SUBJECT: Florida Mining Corporation  
**Mabel Cement Plant**  
DEP File No. 1190040-001-AC (PSD-FL-356)  
Sumter County

## NOTICE OF PERMIT DENIAL

Re: Second Request for Additional Information  
DEP File No. 1190040-001-AC (PSD-FL-356)  
Proposed Portland Cement Plant in Sumter County, Florida

**Subject:** Florida Mining Corporation – Mabel Cement Plant  
Response to Request for Additional Information dated June 24, 2005  
DEP File No. 1190040-001-AC (PSD-FL-356)

FIGURE 1-8. EXACT AND APPROXIMATE REPRESENTATIONS OF A LINE SOURCE BY MULTIPLE VOLUME SOURCES

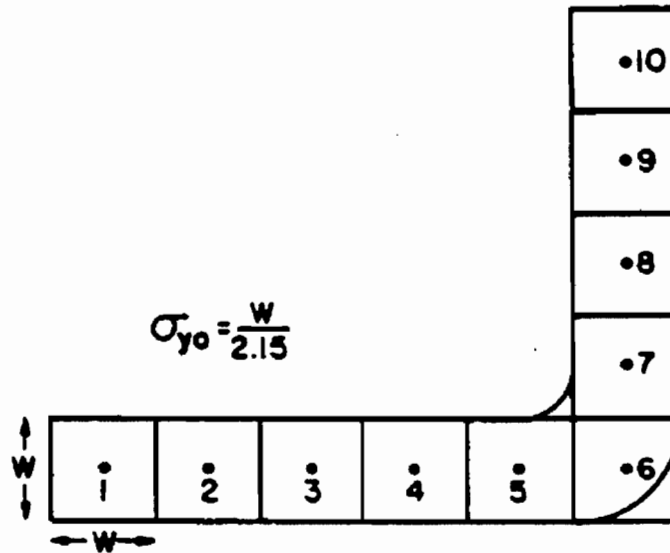
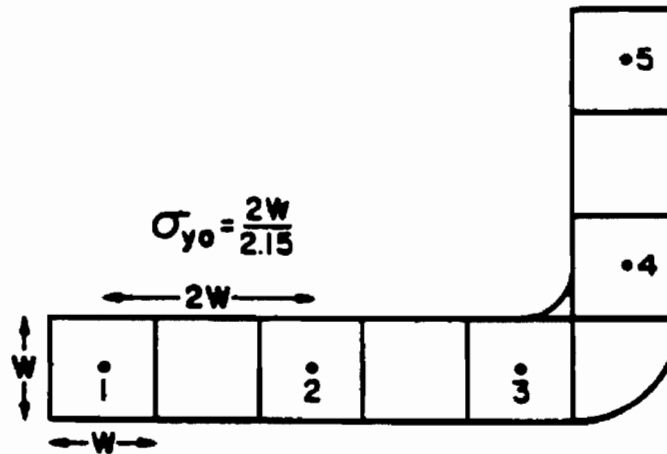
10. Please explain why the initial horizontal and initial vertical dimensions for the rock quarry source were chosen to be 30m.
11. Based on our review of the revised plot plan in Attachment 6, the source BAG was incorrectly located in the PM<sub>10</sub> modeling files. According to the plot plan this source should be located at about 404278, 3162075. Instead it was located at 404170.22, 3161964.75. Please address this discrepancy, and remodel if necessary.

Figure 1-8 illustrates representations of a curved line source by multiple volume sources. Emissions from a line source or narrow volume source represented by multiple volume sources are divided equally among the individual sources unless there is a known spatial variation in emissions.”

For this project, the roadway width is 24 feet. The dimensions of each volume source are therefore 24 feet by 24 feet (7.31 m x 7.31 m). The roadway was modeled using an approximate representation of a line source by multiple separated volume sources. As shown below in Figure 1-8, the spacing between the separated volume sources is twice the width of each volume source (14.63 m).

The initial lateral dimensions (init lat) for a line source represented by separated volume sources (see Figure 1-8(b)) is determined by dividing the center to center distance by 2.15.

FIGURE 38.—Sulfur content of surficial materials.

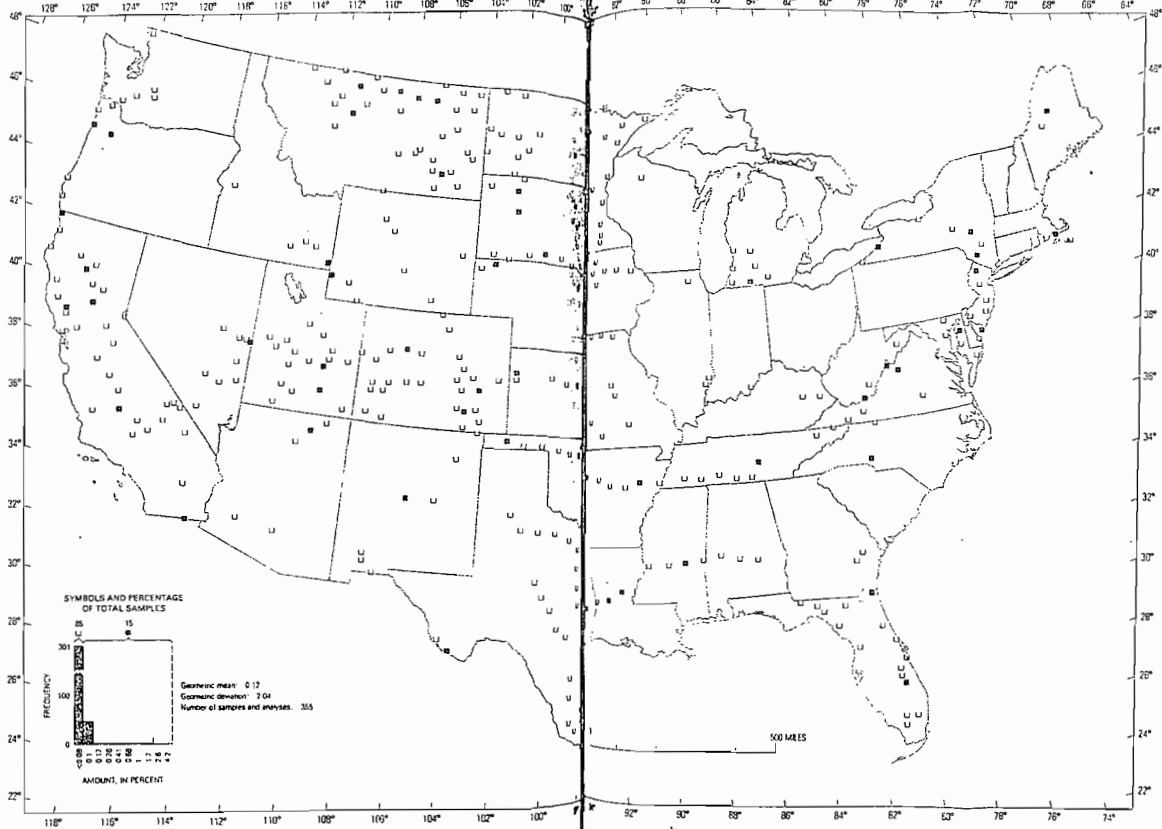
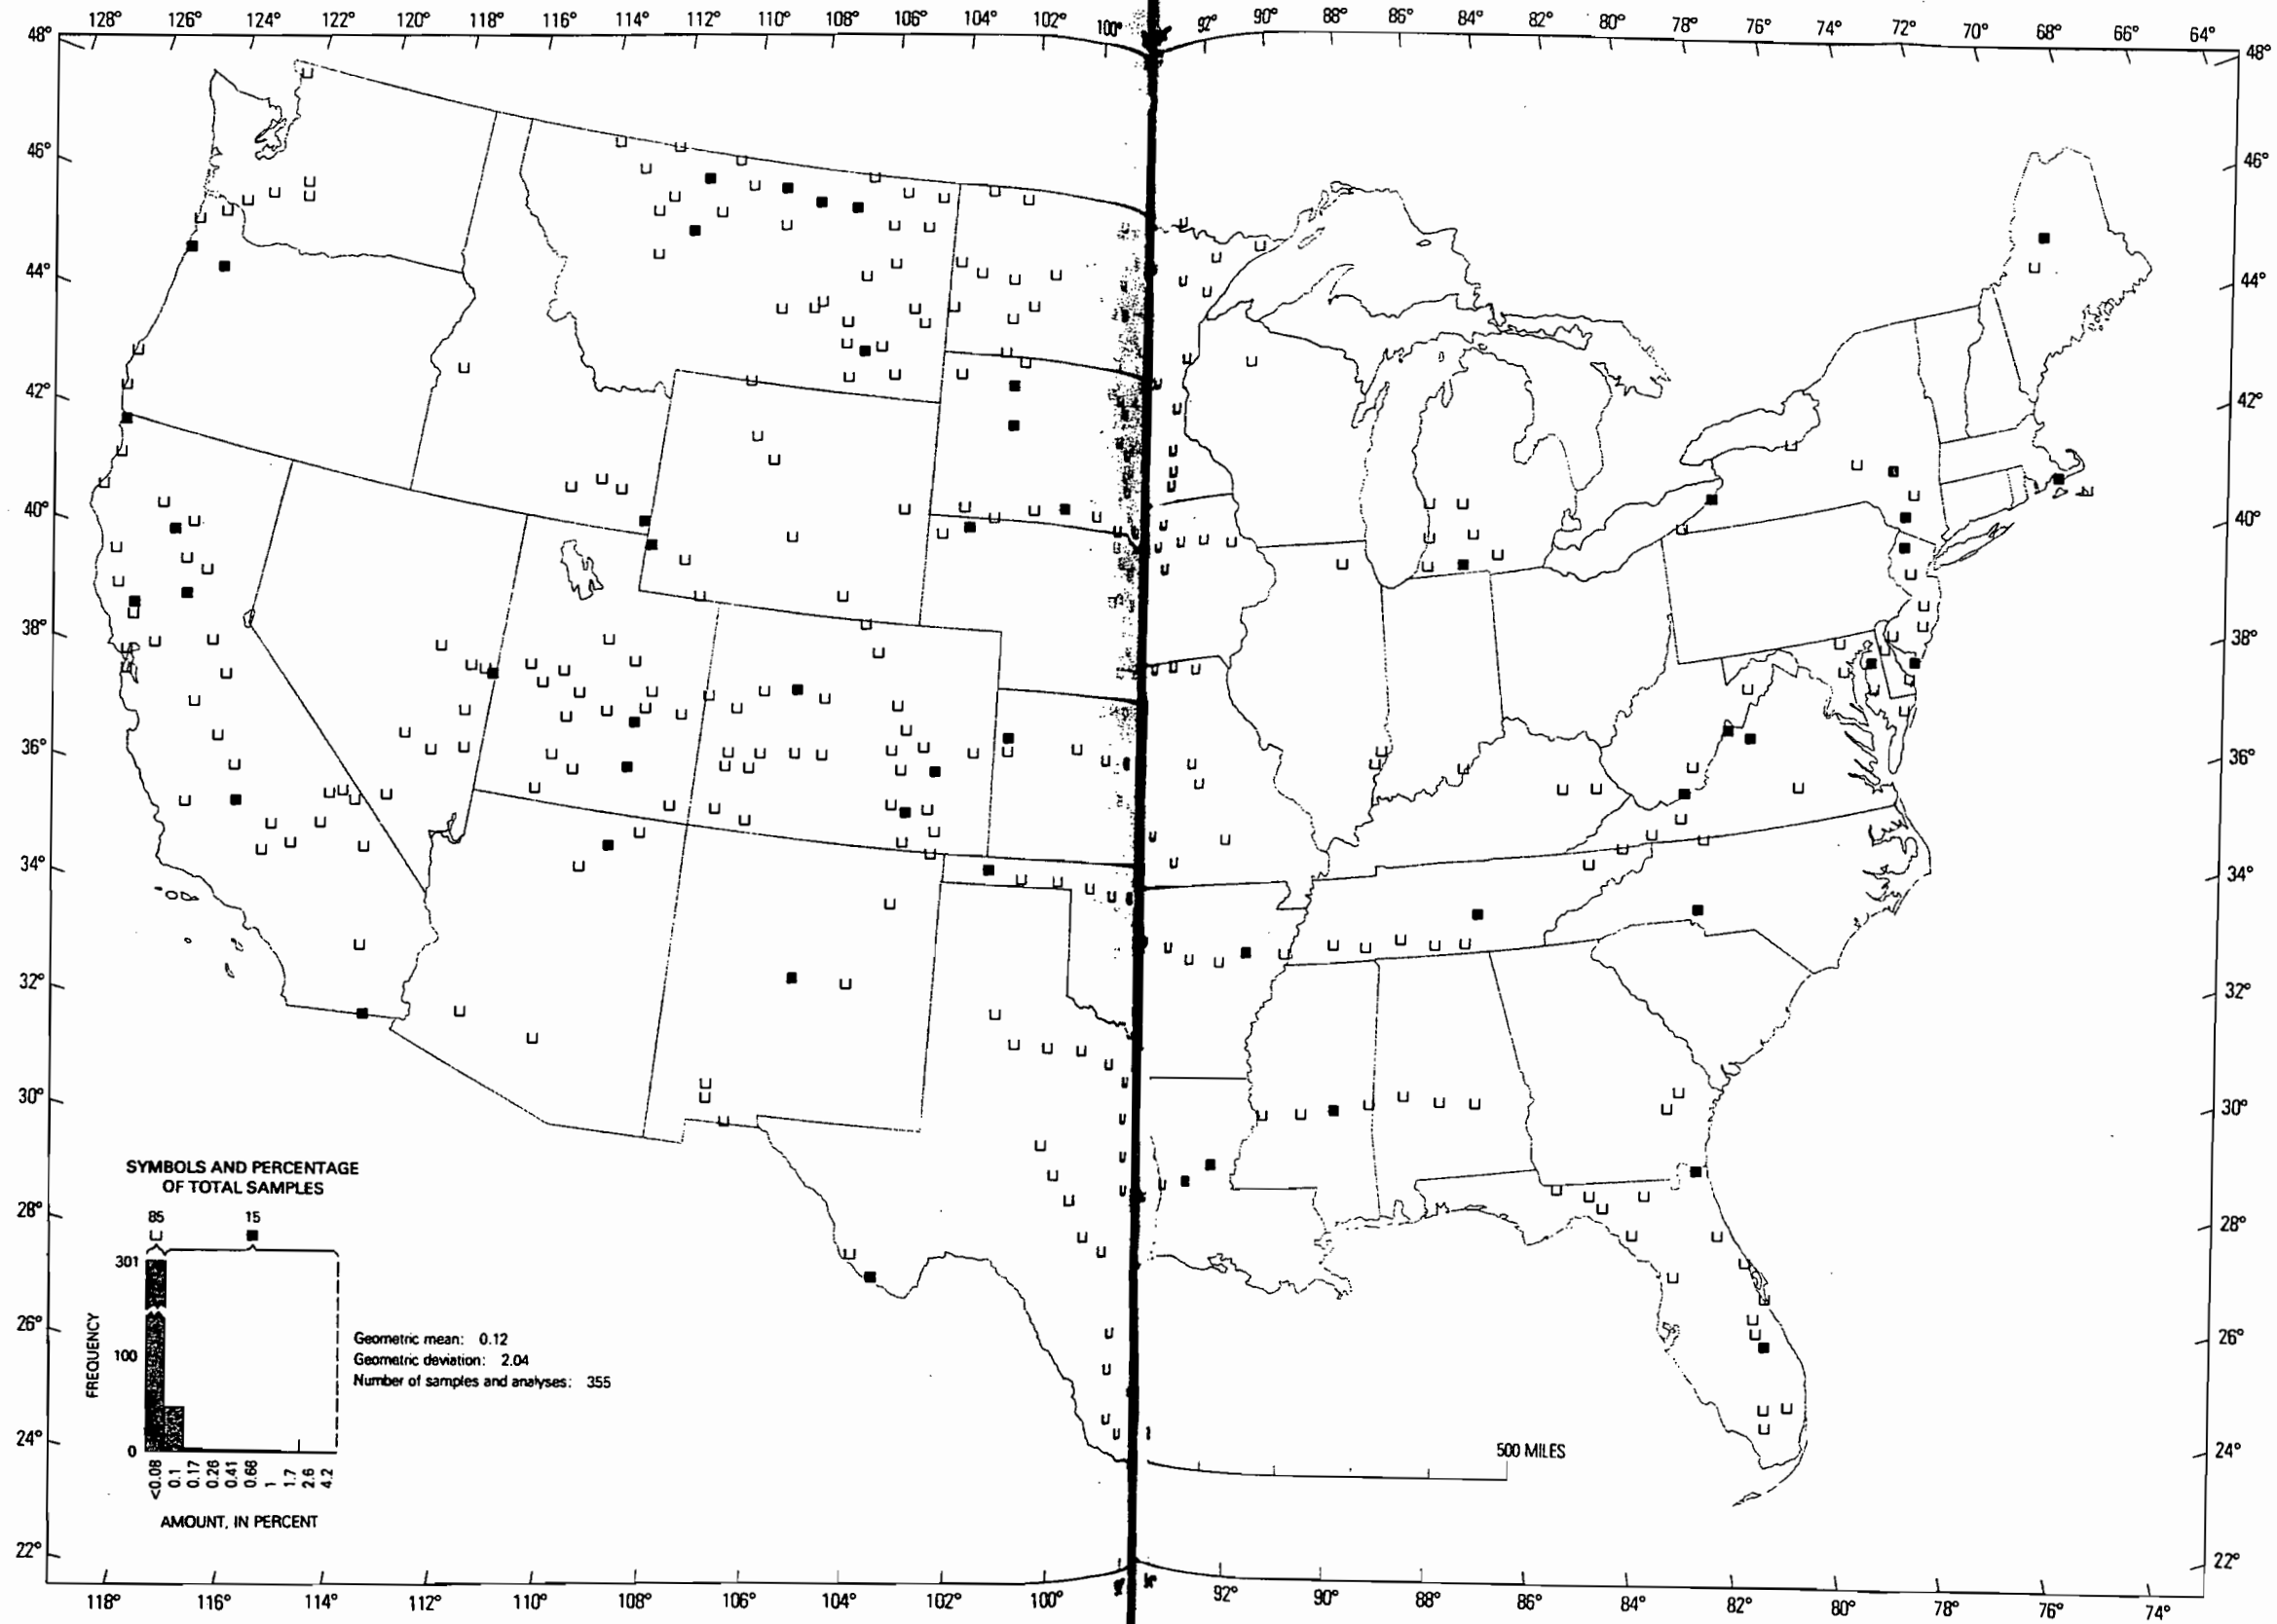
The Holcim Florence plant exceeded its VOC emissions by an order of magnitude after failing to properly consider keragen in their raw material. Florida Rock did not initially anticipate the effects of imported raw material such as mill scale and experienced high but correctable VOC emissions. Suwannee American encountered unexpected sulfur deposits notwithstanding the statement in the response to the Issue 8 that "sulfur in the raw material is assumed to be low, based on data from the USGS".

16. The SO<sub>2</sub> limit for Florida Rock Kiln 1 is 0.16 lb/ton of clinker on a 24-hour basis. They do not practice hydrated lime injection. Please provide a rationale for the greater emission limit request given that hydrated lime injection is available if needed. Please provide data on sulfur in the raw material from the property.

**Response:** Sulfur in the raw material from the property is assumed to be low, based on data from the USGS, included as an attachment to this report. The data show consistently low sulfur content in soils and surficial materials across central Florida, with concentrations of less than 0.08 percent.

Sulfur in the raw material from the property is assumed to be low, based on data from the USGS, included as an attachment to this report. The data show consistently low sulfur content in soils and surficial materials across central Florida, with concentrations of less than 0.08 percent.

**ATTACHMENT 5**  
**Road Source Diagram**

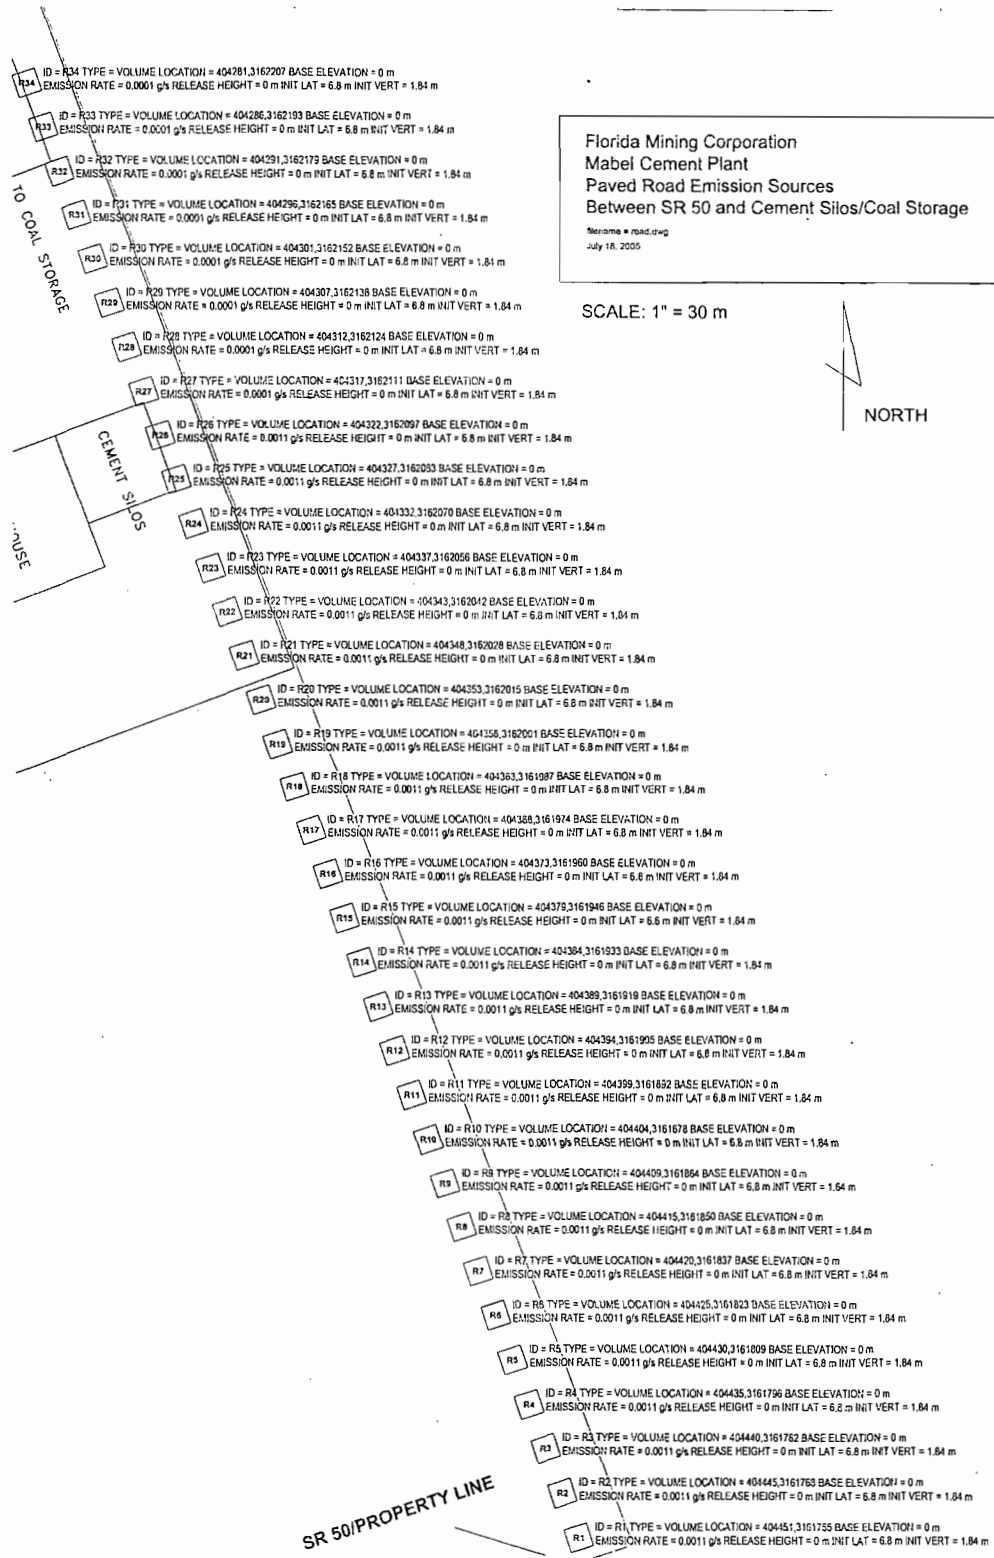
25. Please provide a detailed discussion of the truck traffic that will be generated from the construction and operation of the kiln. Some of this information has already been provided on your spreadsheets describing the road sources. Please show where the values of 6.8 for init lat and 1.84 for init vert came from in your spreadsheet describing the paved roads emissions estimation. Please discuss how the release height of 0 meters was chosen. Please provide a diagram showing each road segment, its location and its emission parameters.

A diagram is included as an attachment to this response, showing each road segment, its location and its emission parameters.

**ATTACHMENT 6**  
**Revised Plot Plan**

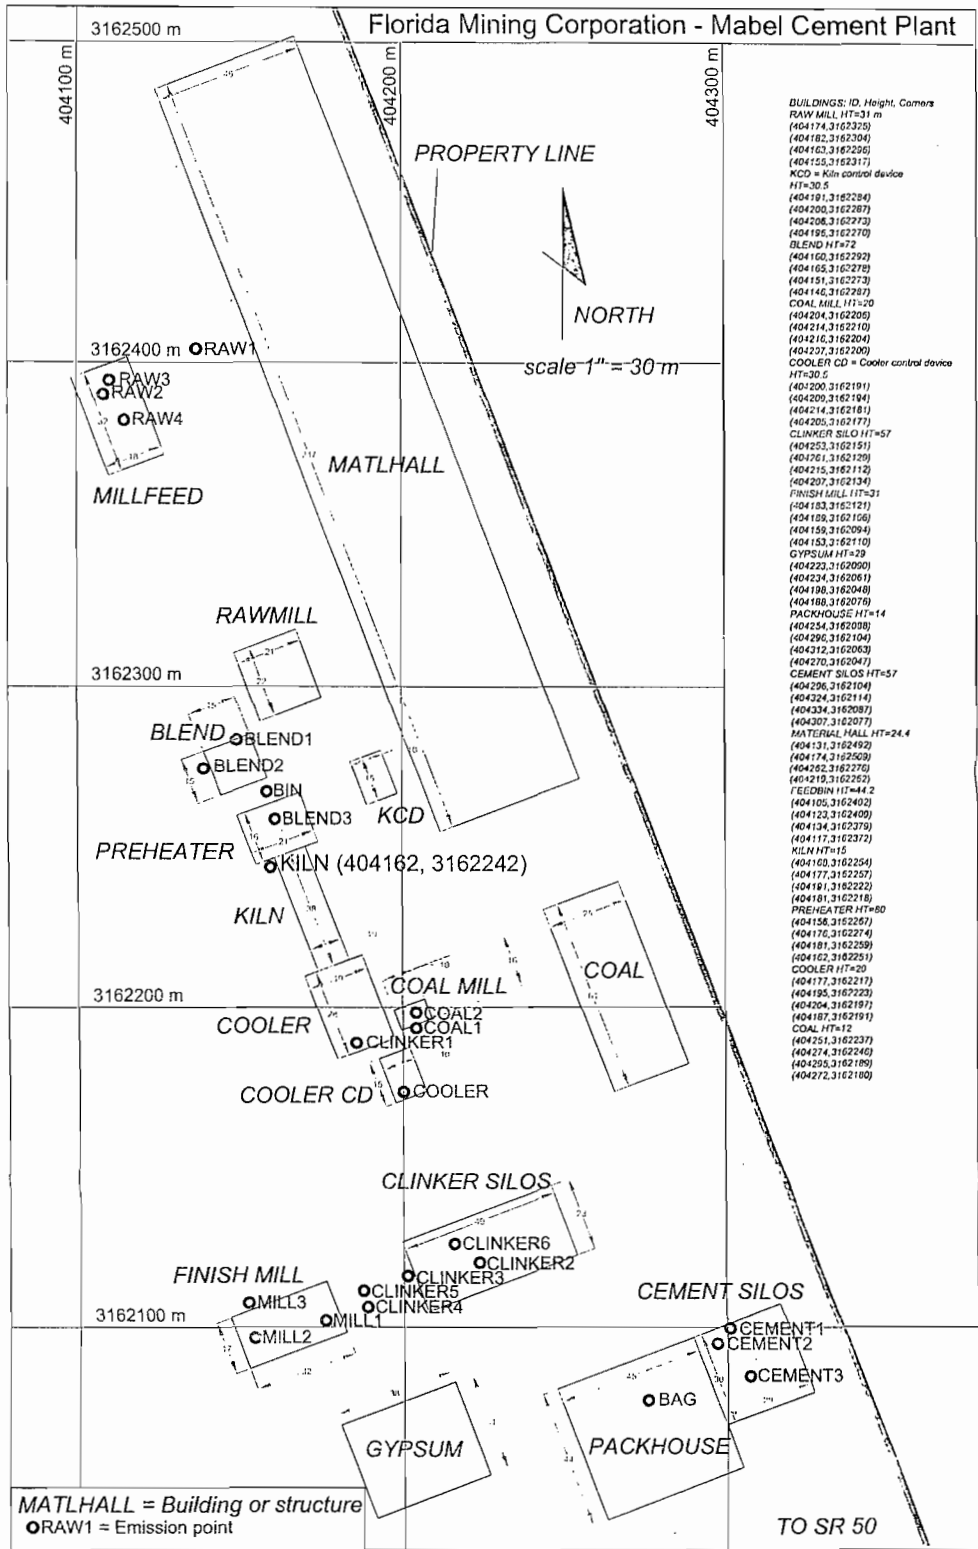
26. The facility plot plan on page 11 does not show the dimensions and location of the buildings and structures on the property. Please provide a plot plan with UTM coordinates overlaid in a 100 meter grid showing the locations and the dimensions of the buildings and structures.

**Response:** The previously submitted facility plot plan showing dimensions and locations of proposed buildings and structures did not reproduce well. A revised plot plan with UTM coordinates overlaid in a 100 meter grid showing the locations and the dimensions of the buildings and structures is included as an attachment to this response.
